Drain: BRIDGEWATER DRAIN **Drain #:** 245
Improvement/Arm: BRIDGEWATER - SECTION 2
Operator: JDH **Date:** _____
Drain Classification: Urban/Rural **Year Installed:** 1992

RE: Bridgewater Drain, Section 2 Arm

TO: Hamilton County Drainage Board

RE: Bridgewater Drain-Section 2

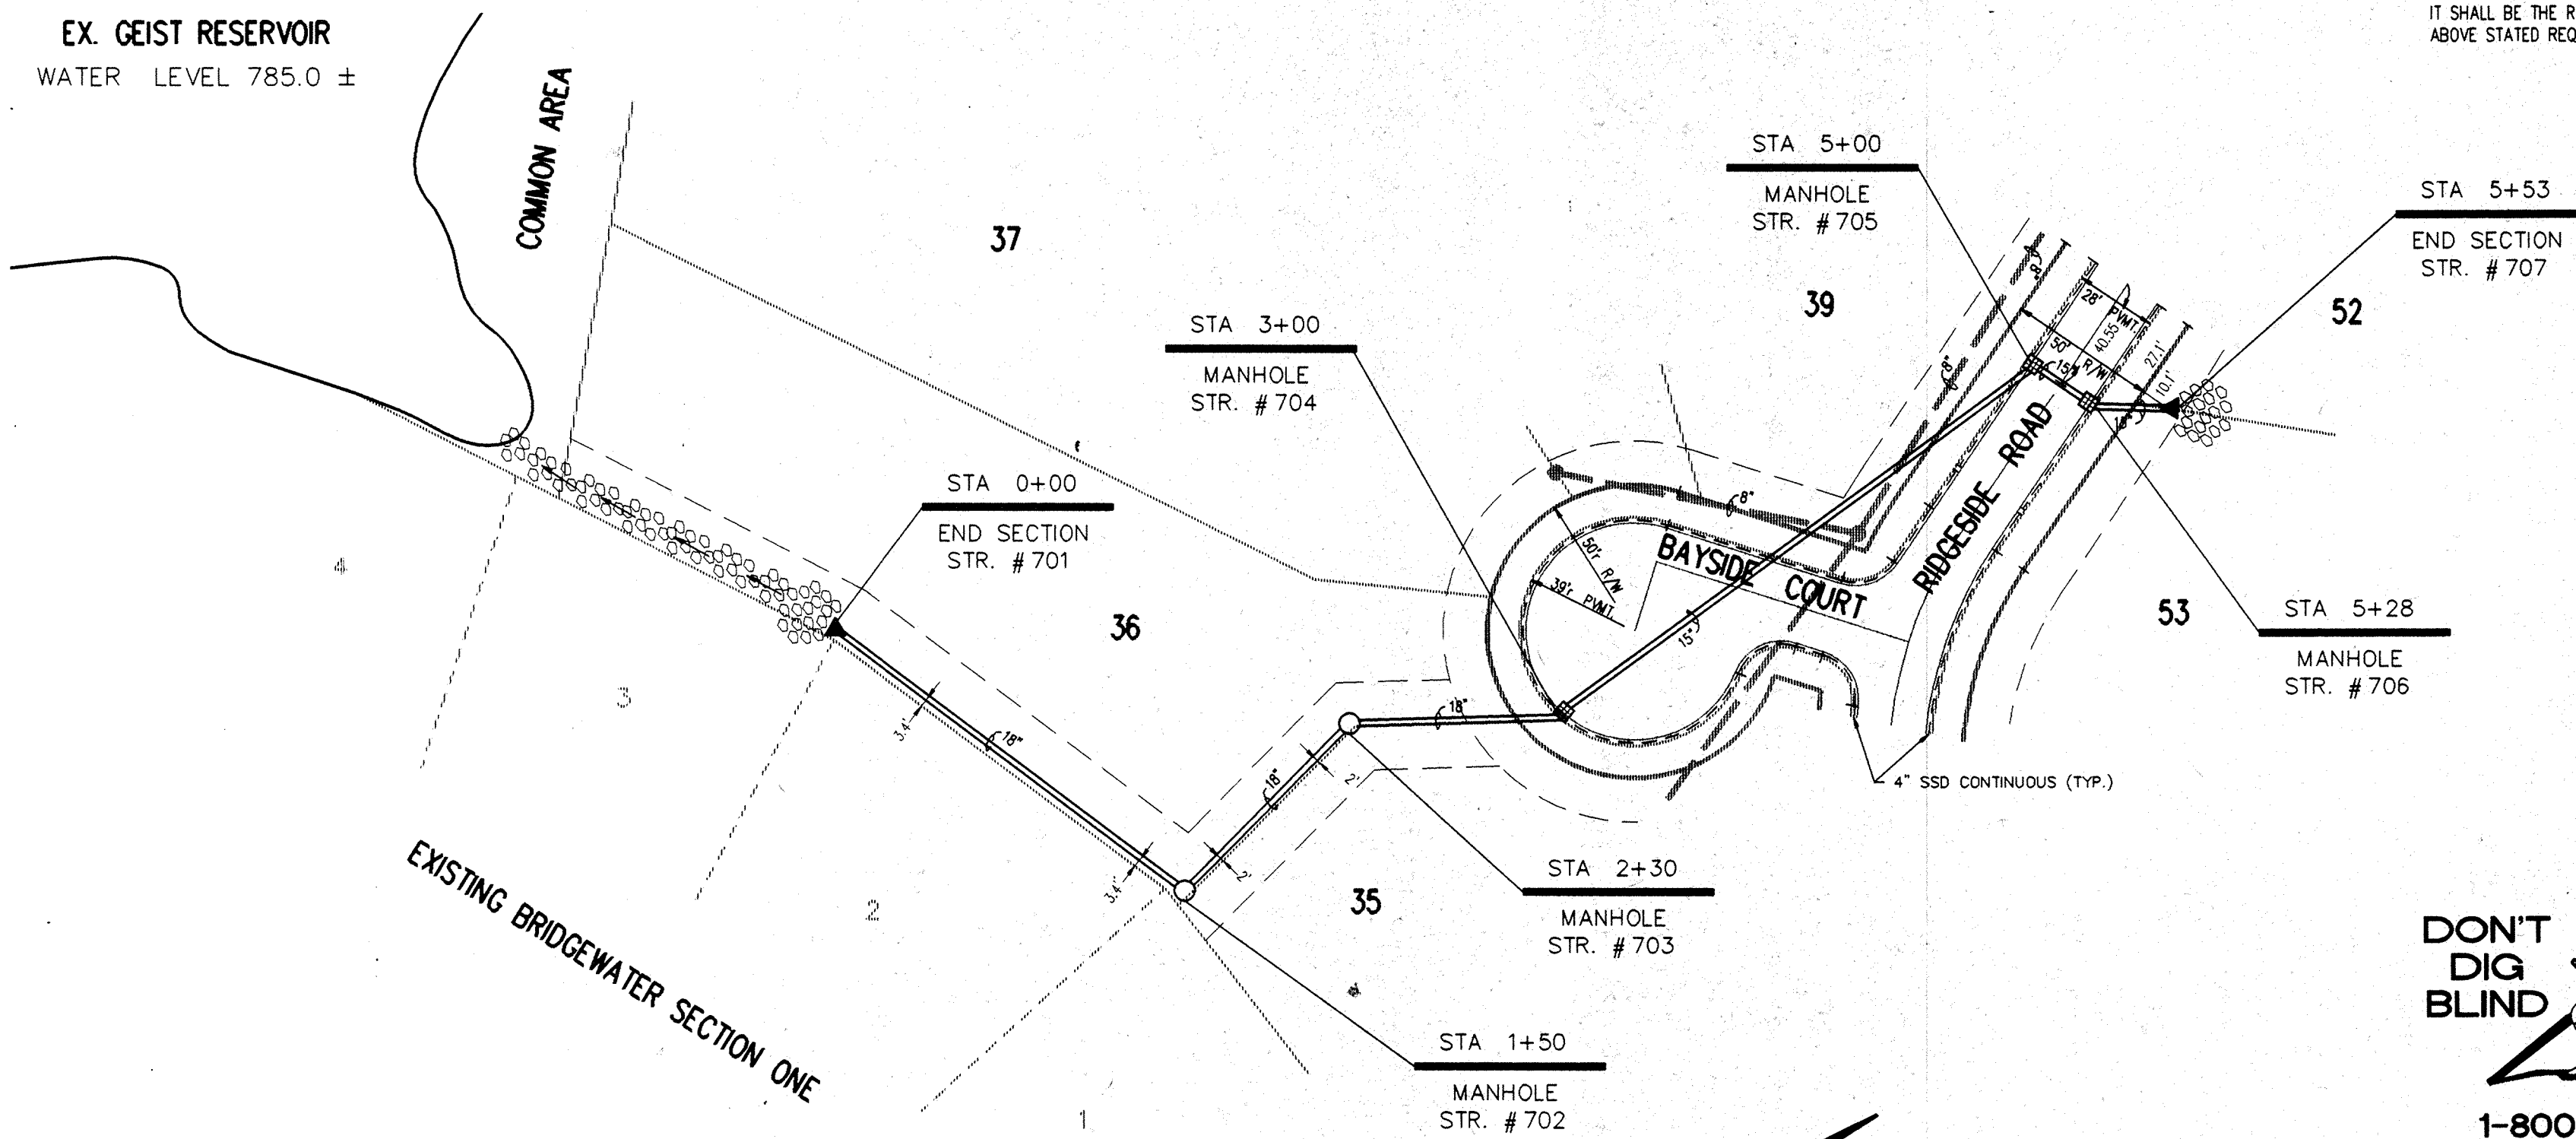
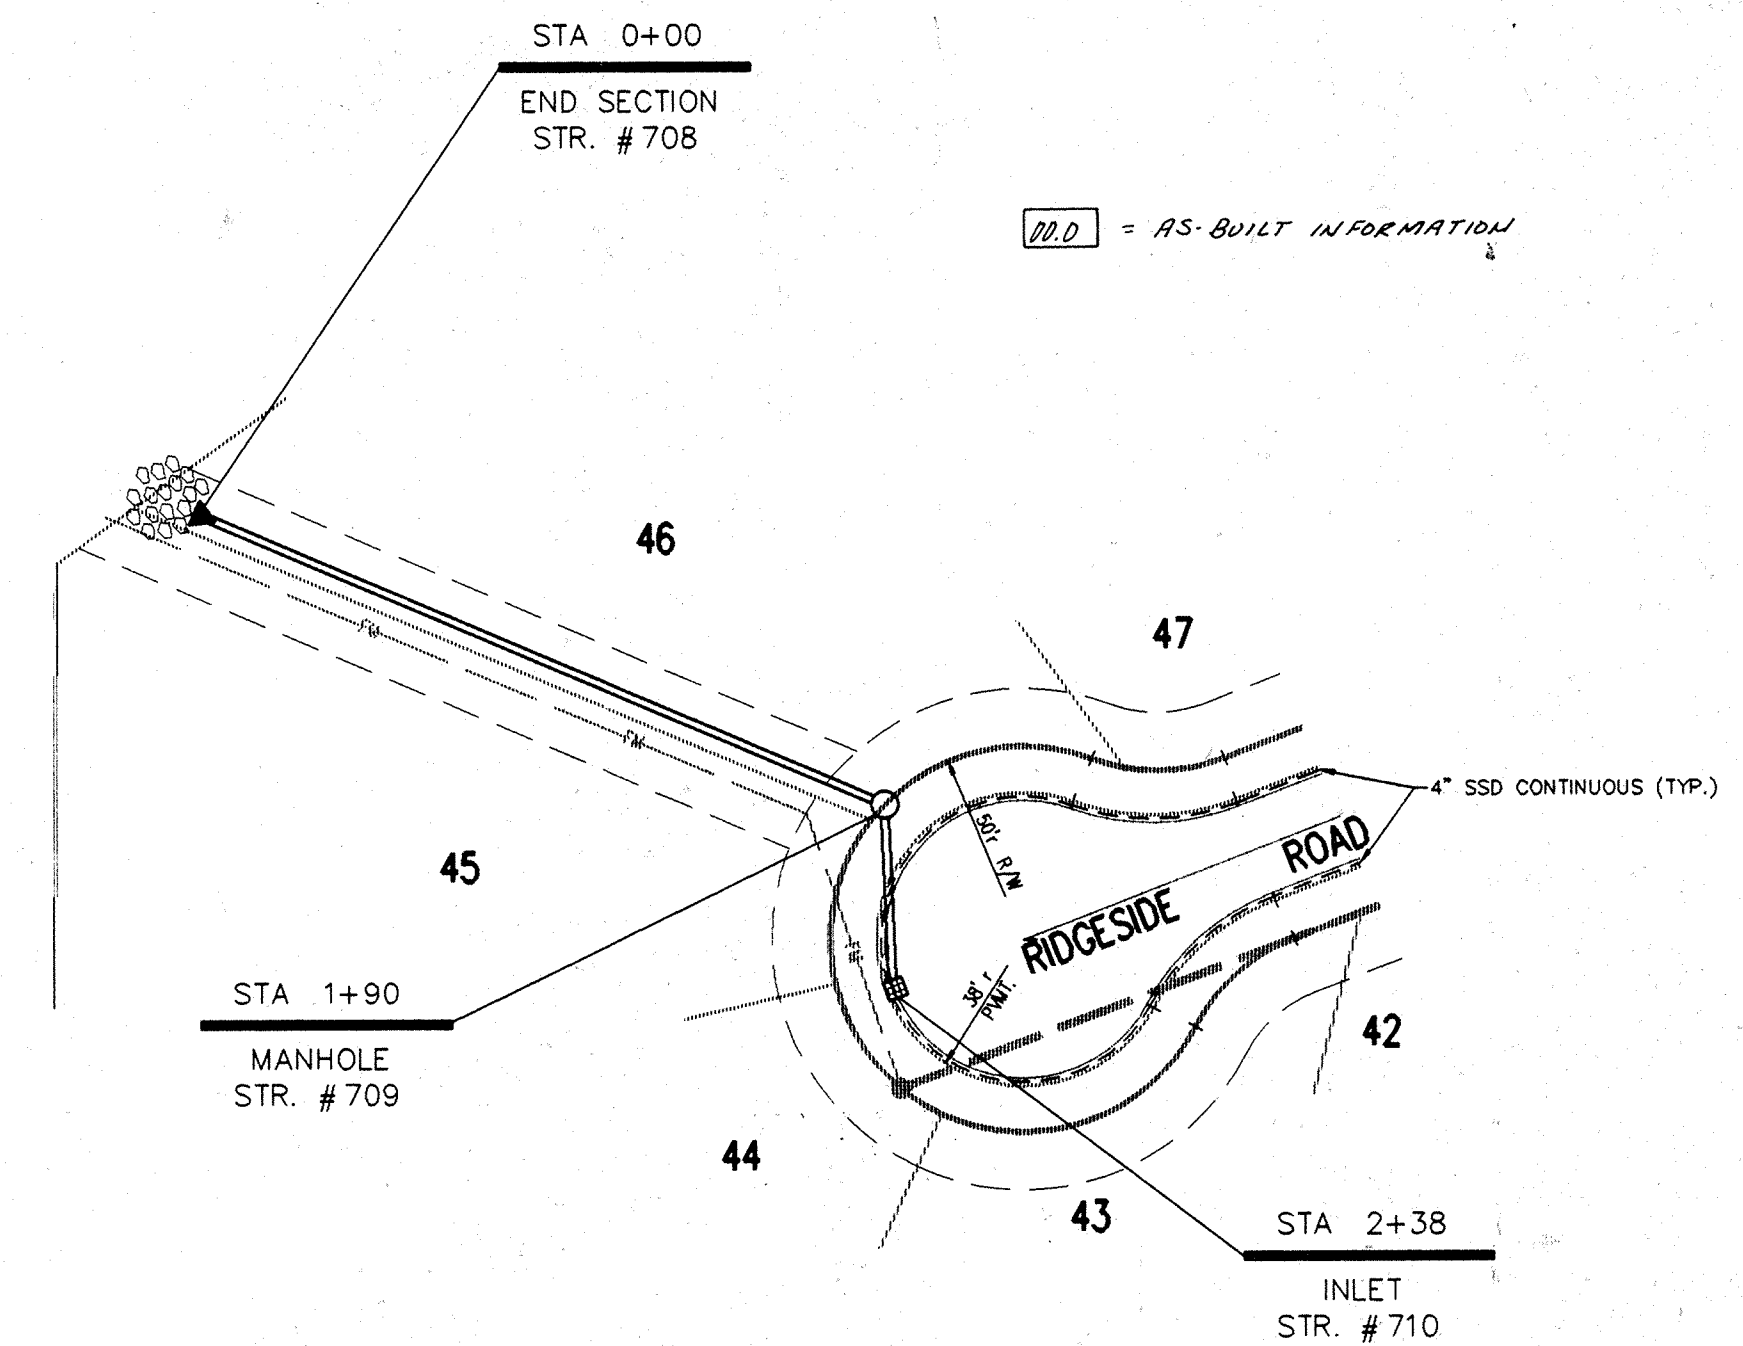
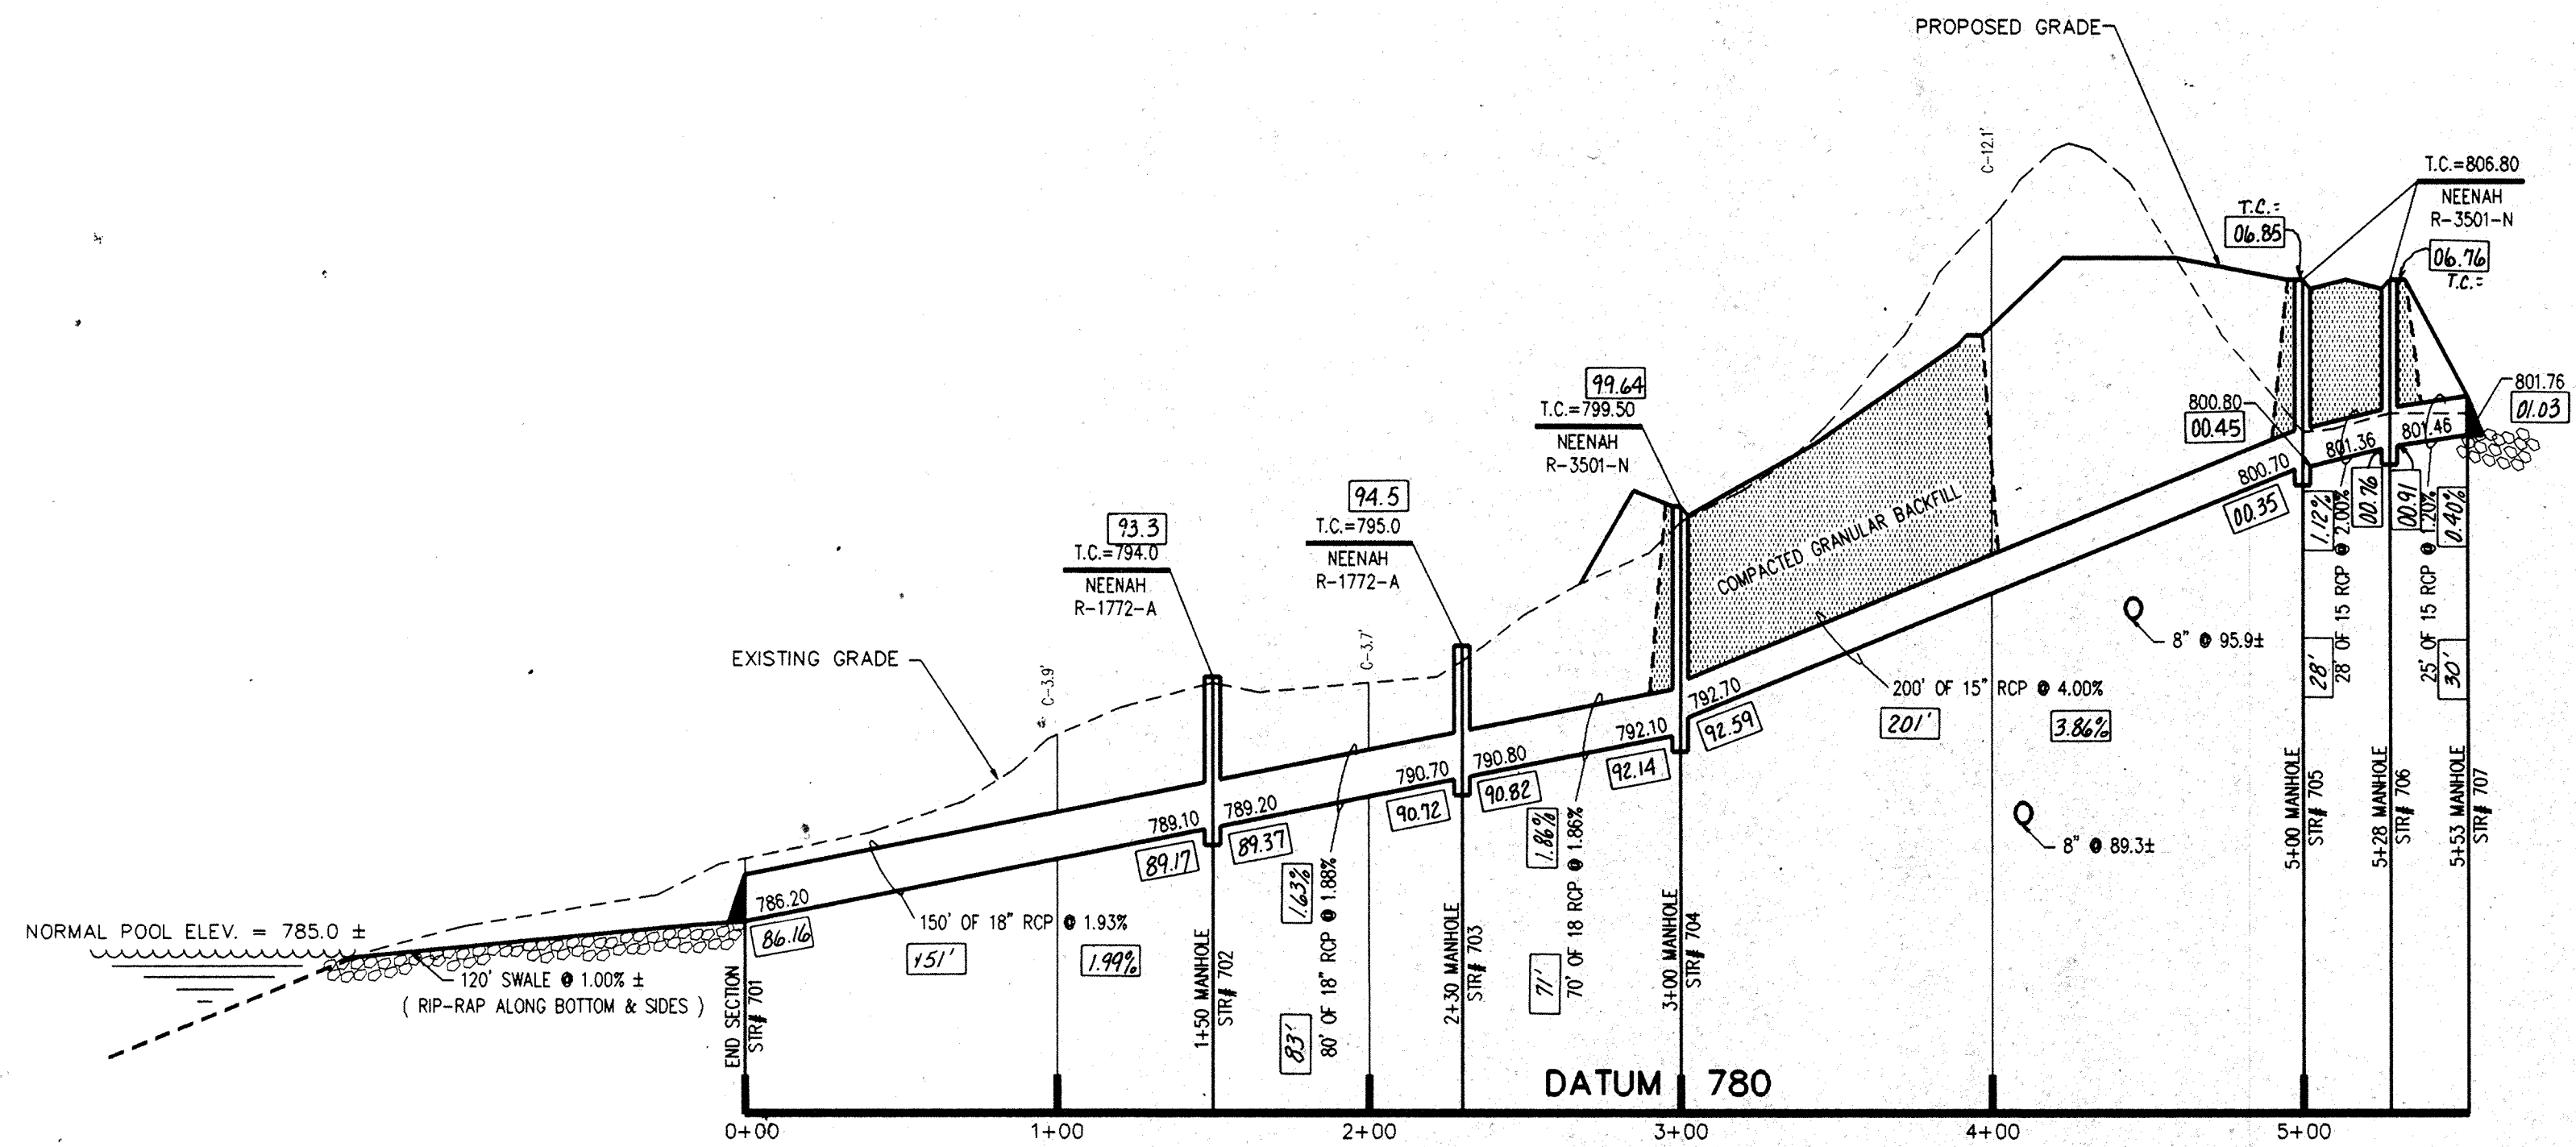
During construction, changes were made to the drain which will alter the plans submitted with my report for this drain dated September 24, 1992. The changes are as follows:

STR	710 to 709	12" RCP	lengthened from	48'	to	52 feet
STR	709 to 708	12" RCP	shortened from	190'	to	189 feet
STR	707 to 706	15" RCP	lengthened from	25'	to	30 feet
STR	705 to 704	15" RCP	lengthened from	200'	to	201 feet
STR	704 to 703	18" RCP	lengthened from	70'	to	71 feet
STR	703 to 702	18" RCP	lengthened from	80'	to	83 feet
STR	702 to 701	18" RCP	lengthened from	150'	to	151 feet

The length of the drain due to the changes described above is now 2,905 feet.
